**GM SERVICE AND PARTS OPERATIONS  
DCS1672  
URGENT DISTRIBUTE IMMEDIATELY**

Subject: 06079 F/CMVSS Non Compliance Recall  
Certification/Tire Label Missing Information

## F/CMVSS NONCOMPLIANCE RECALL

**SUBJECT:** Certification/Tire Label Missing Information

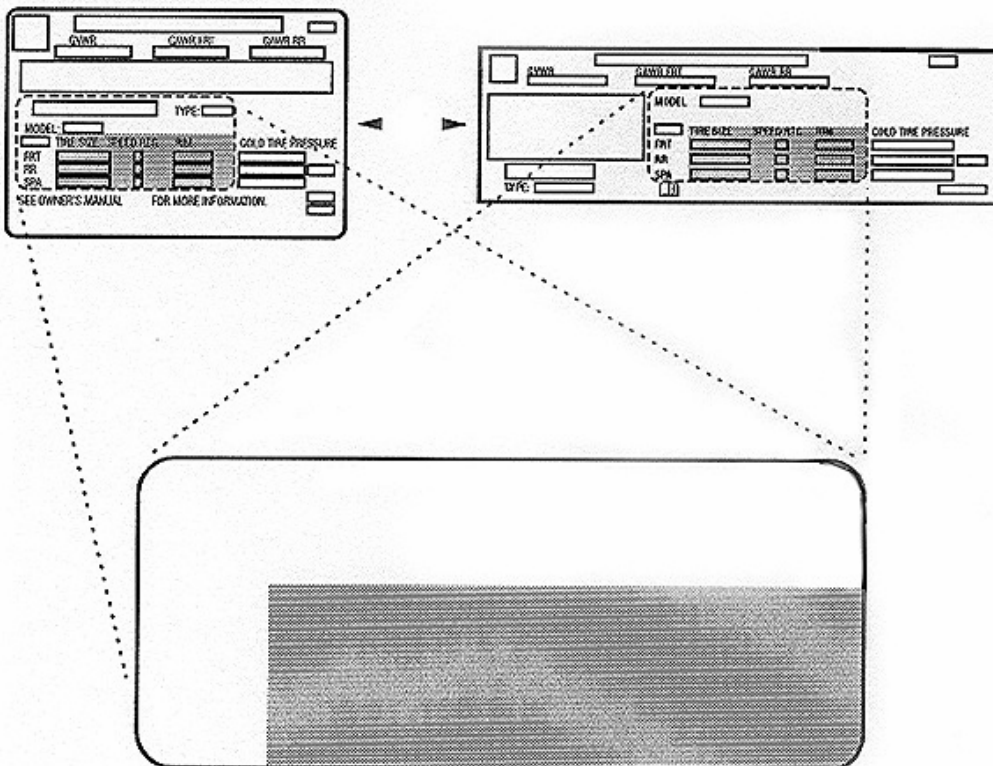
2. Locate the Certification/Tire Label. The label is located on the driver's door edge and should look like one of two labels in the above illustration.
3. Ensure that the current label and surrounding area is clean and dry. Use a non-oil based cleaner, preferably isopropyl alcohol.
4. Remove the backing from the new label.
5. Carefully align the new label (1) over the matching text on the current label.
6. Apply the label and smooth the label from the center out.
7. Close the door.

Dealers are to install a new partial label over the existing label. Because this label can easily be installed by the customer, and to reduce their inconvenience, corrected labels and application instructions will be mailed to customers of record. Dealers will receive labels for installation on the vehicles in inventory. **This recall will expire December 31, 2006.**
